RE: SP201200013 Kenridge
TAX MAP 60K PARCELS A1, A2, B1, B2, B3, 1-47, 49-61

KENRIDGE

AMENDMENT TO SP 20090006 CONDITION #9

FRONT ELEVATION

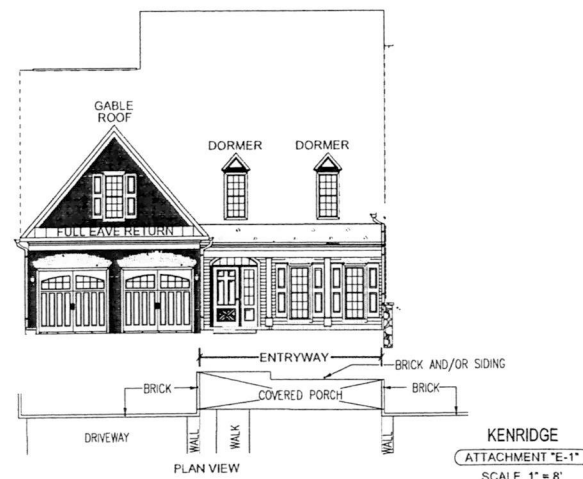
- a) Front facing exteriors shall consist of gable and/or hip roofs with red brick to the roof line (See Attachments E-1 and E-2)
 - b.) Side facing exteriors shall consist of gable and/or hip roofs with red brick to the full eave return and/or roof line (See Attachment E-2). As an alternative to red brick, white composite siding is permissible above said full eave return to the roof line.

REAR ELEVATION

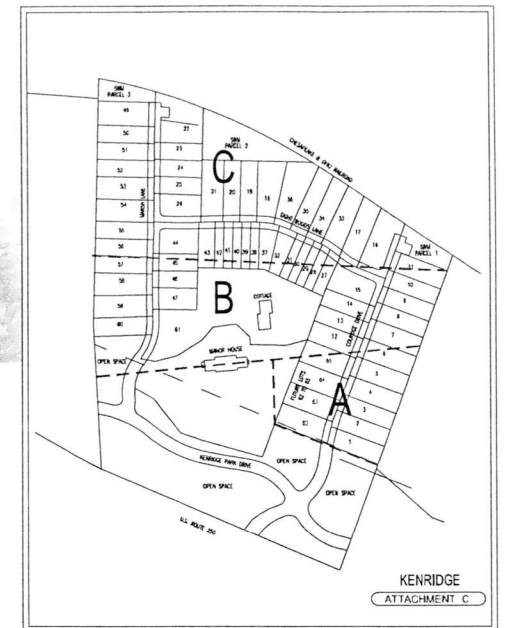
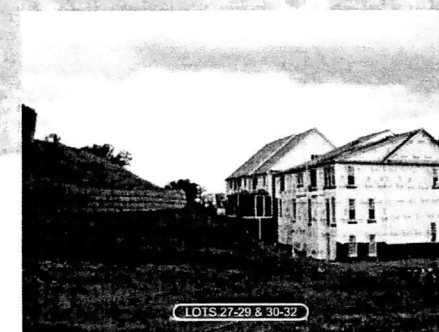
- c.) Rear facing exteriors shall be red brick from the ground floor to the roof line except as follows (See Attachment E-3)
 - i.) Lot 19 shall be red brick from the ground floor to the first floor. White composite siding is permitted from the first floor to the roof line

- ii) Lots 30, 31, and 32 shall be red brick from the ground floor to the second floor. White composite siding is permitted from the second floor to the roof line
